DEPARTMENT OF THE ARMY
SAN FRANCISCO DISTRICT, U.S. ARMY CORPS OF ENGINEERS
1455 MARKET STREET
SAN FRANCISCO, CALIFORNIA 94103-1398

SUBJECT: File Number 2007-400560S

FILE NUMBER: 2007-00560S
PROJECT: Grand View Terrace
DATE: 11/24/09
SUBJECT: Appeal Remand

Administrative Appeal Conference
Army Corps of Engineers, San Francisco District
Grand View Terrace Property
Jurisdictional Determination, File Number 2007-00560
Prepared by Paula Gill, March 31, 2009

Photograph taken by Paula Gill 12/12/09. Standing water apparent between the two red lines in the photograph above. Bent vegetation is also indicative of flowing water in the channel. Water was approximately 2-5" deep and about 3" below the ordinary high water mark.

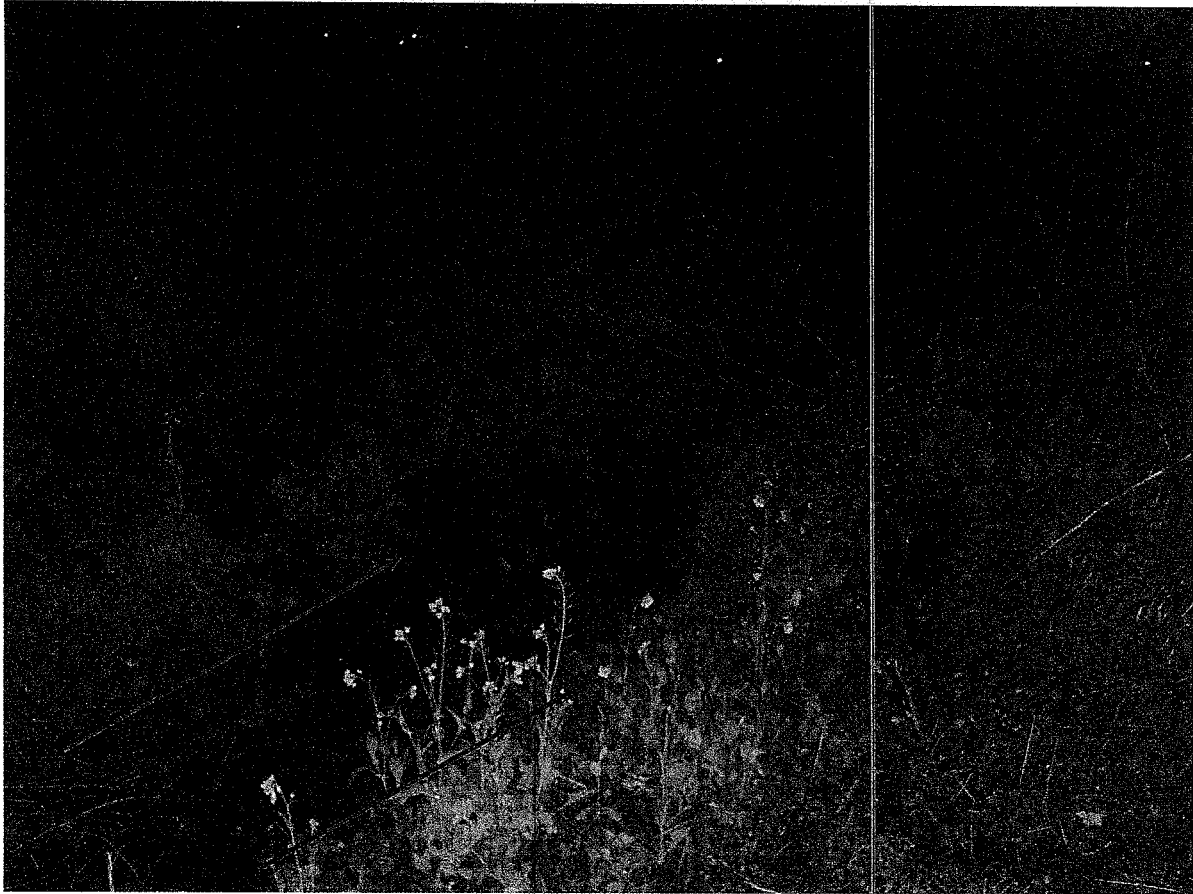
Site Visit: After the first heavy rains of the season (December 11-13, 2009) the District Project Manager, Paula Gill, traveled to the site in the evening (approximately 1730) to confirm the presence of water in the channel. Permission to access the property had not been obtained, so the drainage at the southwest corner of the property was observed from a public street (Golden Gate Avenue). The site visit was intentionally made toward the end of one of the first heavy rain events of the season to demonstrate that the ditch would be holding water early in the season.

Study Area location relative to larger wetland complex on Grandview Terrace property, created November 23, 2009. Aerial photograph from Google Earth image dated 6/2007.

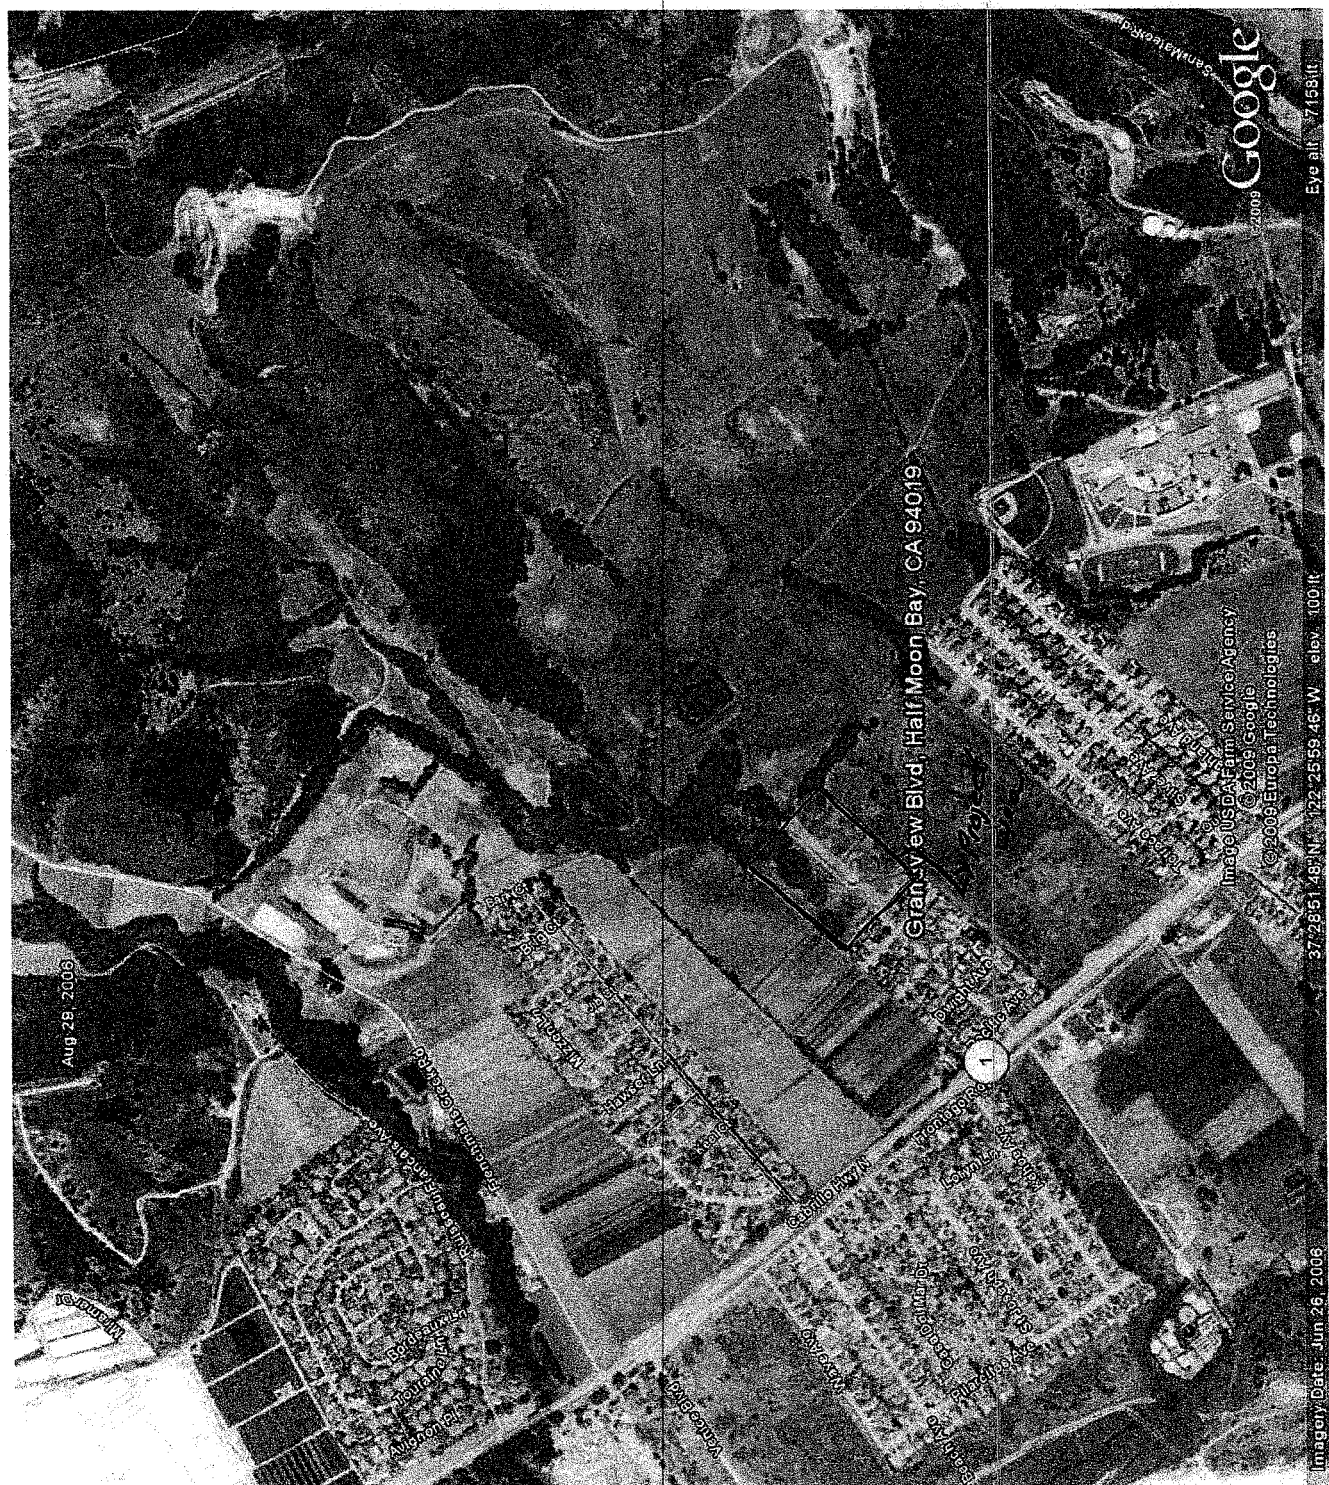
As depicted in the current Google Earth image titled "Study Area location relative to larger wetland complex on Grandview Terrace property" and dated November 23, 2009, it is clear that the wetlands on the Grandview Terrace property are a part of a larger wetland complex that extends up-watershed of the project site (enclosure 8). Wetland systems dominated by perennial phreatophytes, such as willow, retain soil moisture for prolonged periods beyond rainfall events. As lower watershed features dry down or drain to the TNW the upper watershed wetlands beyond the project site continue to provide moisture to lower watershed wetlands (i.e. wetland recharge). The result is prolonged soil moisture beyond the rainfall event within the larger system. The perennial nature of the wetlands on the site is depicted in the Google Earth image titled "Google Earth Image dated August 29, 2006." This image is from

Google Earth Image dated August 29, 2006. Image taken at end of summer when annual plants have senesced and turned brown. Wetland complex still apparent (green signature). Created November 23, 2009.

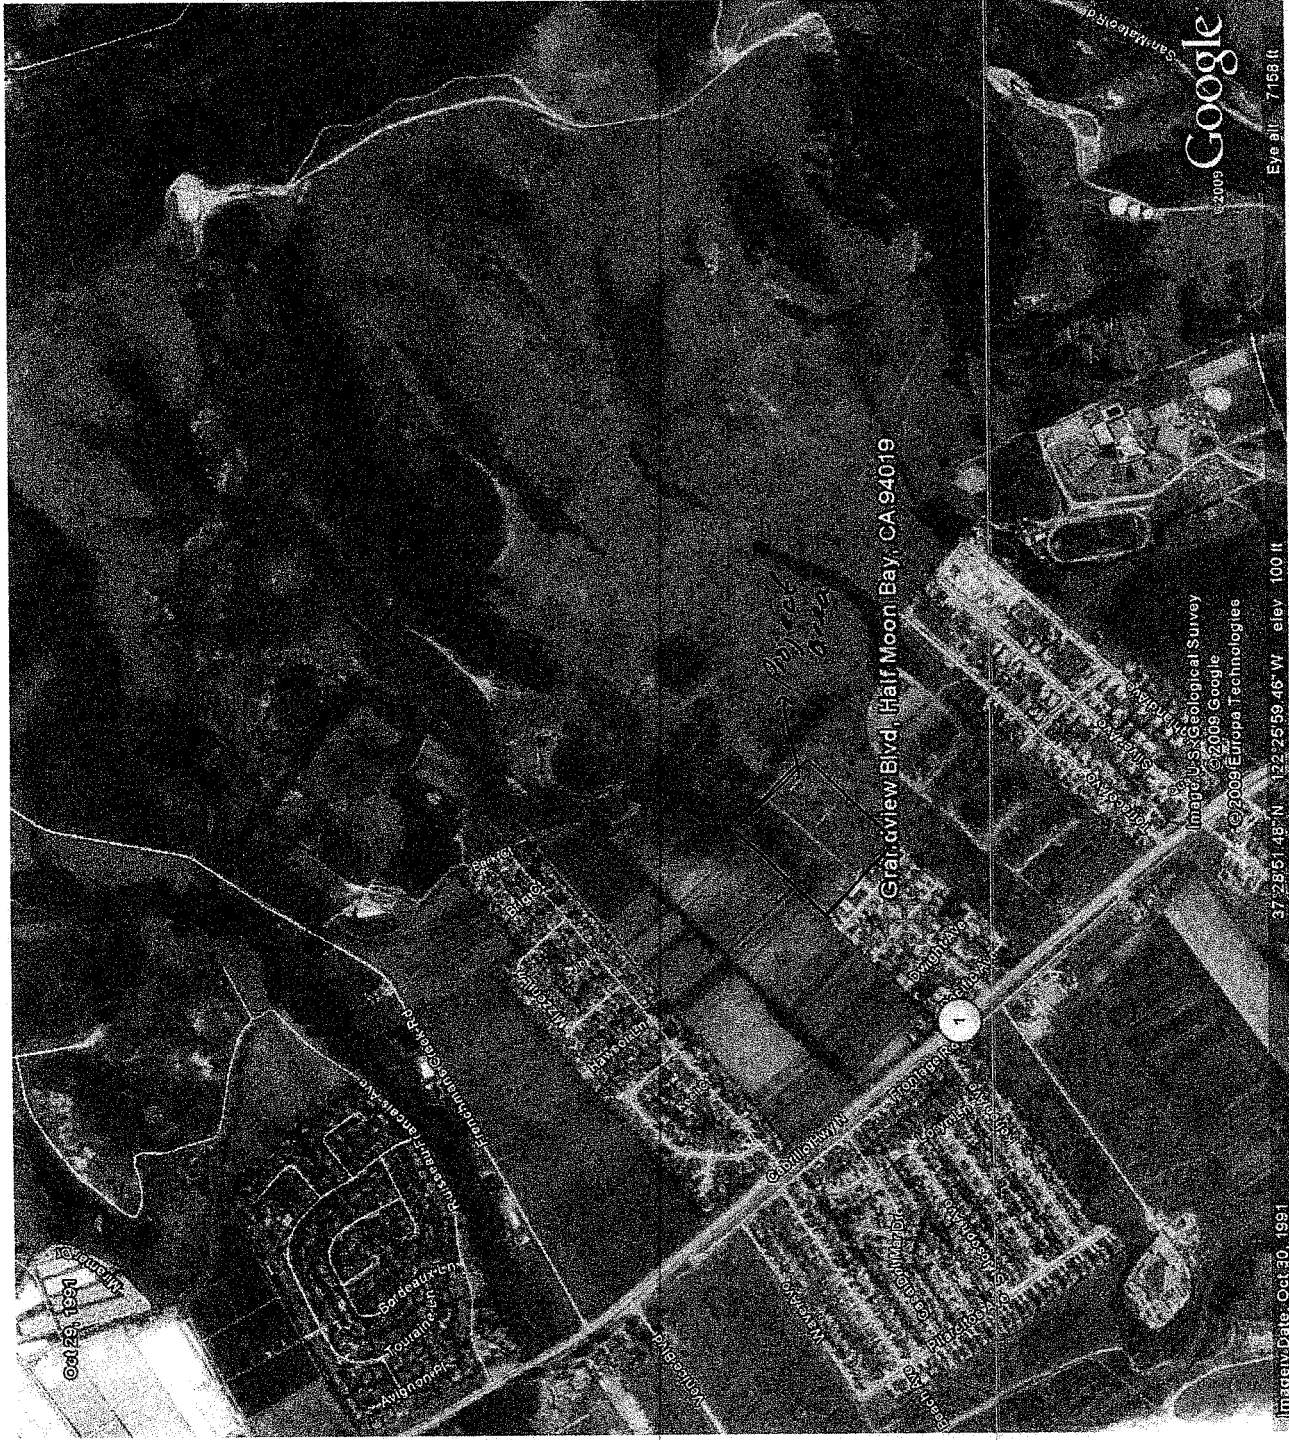
August when at the end of the summer months prior to the winter rains. In California's climate August would be the driest time of year, yet a green wetland signature is still apparent on the aerial photograph (enclosure 9). The figure titled "Google Earth Image dated October 29, 1991" shows the wetland complex and arroyo willow swale on the site has been established since 1991 (enclosure 10).
